## **ADDENDUM #2**

RFQ # 7598641 TITLE: WORKSTATIONS - DOT SUBMISSION DEADLINE: MARCH 7, 2019 – 11:00 A.M.

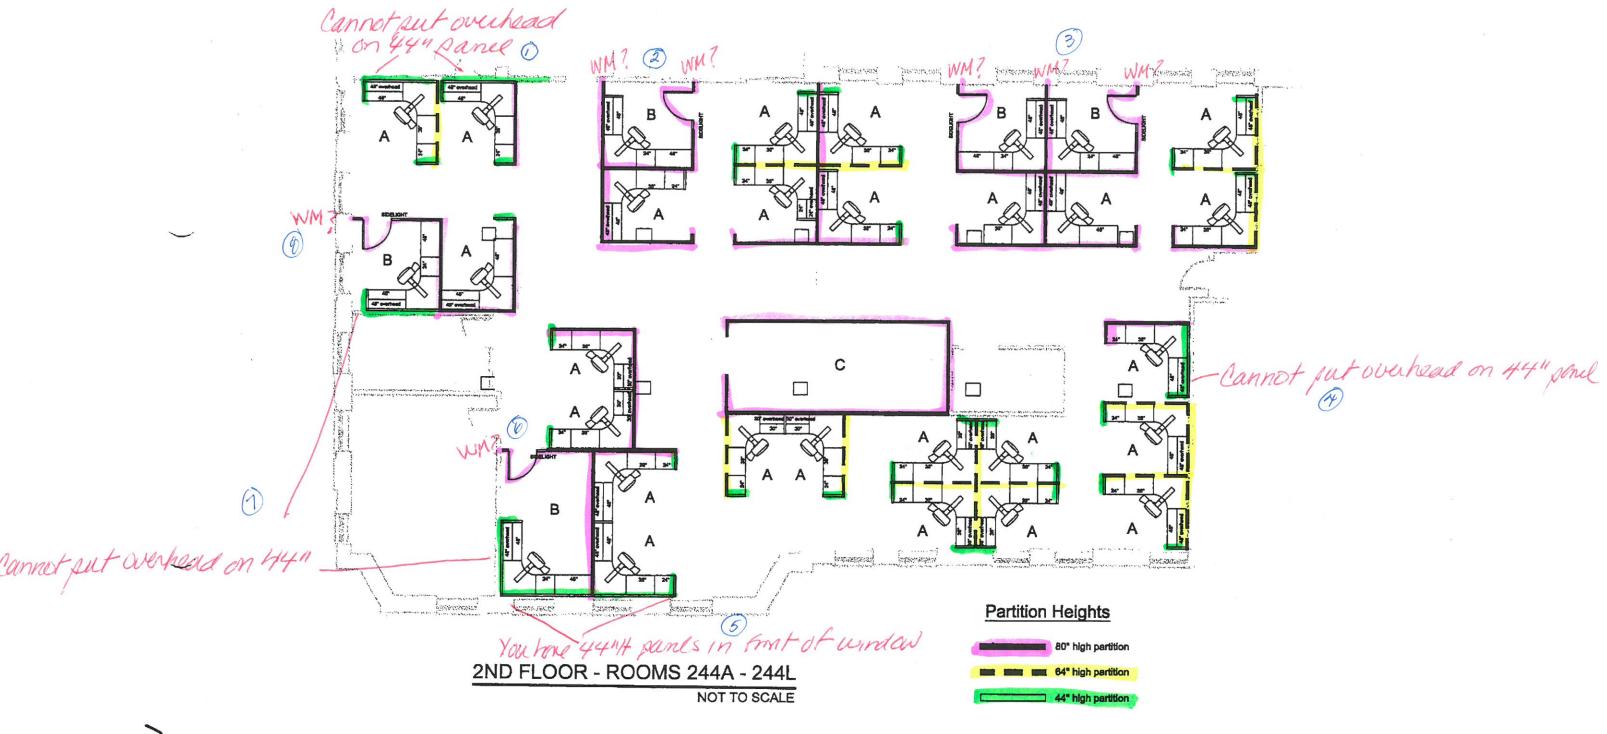
- 1. We cannot put overheads on a 44"H panel. Do you want me to remove them or change the panel height to 64"H? Either way we will be blocking the windows. Make these panels 64" and keep the overheads. Move the overheads above the curved corner worksurface

- 2. Drawing shows two wall mounts. I was told we could not wall mount any more. Should we box this 80"H station in? If so, we will be blocking the windows. Box in the assembly. There are no windows here.

- 3. Drawing shows three wall mounts. I was told we could not wall mount any more. Should we box this 80"H station in? If so, we will be blocking the windows. Yes. If a window is present, provide the maximum width of 80" high return panel possible to stabilize the assembly. Keep the windows clear. If needed for stability, utilize a 30" high open frame panel at the windows

- 4. We cannot put overheads on a 44"H panel. Do you want me to remove them or change the panel height to 64"H? Either way we will be blocking the windows. Change the panel height to 64". This is an interior wall with no windows. . Move any overheads that conflict with windows above the curved corner worksurface

- 5. You have 44"H panels in front of the windows. You will be blocking. Do you want me to lower them to 30"H? Lower them to 30". Provide open frame panels here to accommodate the heating radiators at each window

- 6. The drawing shows a wall mount. I was told we could not wall mount any more. Should we box this 80"H station in? Yes. If a window is present, provide the maximum width of 80" high return panel possible to stabilize the assembly. Keep the windows clear. If needed for stability, utilize a 30" high open frame panel at the windows

- 7. These two locations show overheads on 44"H panels. Should we remove or change the panel height to 64"H? The lower office will be boxed in. Overheads should not be an issue here. The other office will be boxed in per #8 below. The overhead should not be an issue.

- 8. The drawing shows a wall mount. I was told we could not wall mount any more. Should we box this 80"H station in? If so, we will be blocking the windows. Yes. If a window is present, provide the maximum width of 80" high return panel possible to stabilize the assembly. Keep the windows clear. If needed for stability, utilize a 30" high open frame panel at the windows
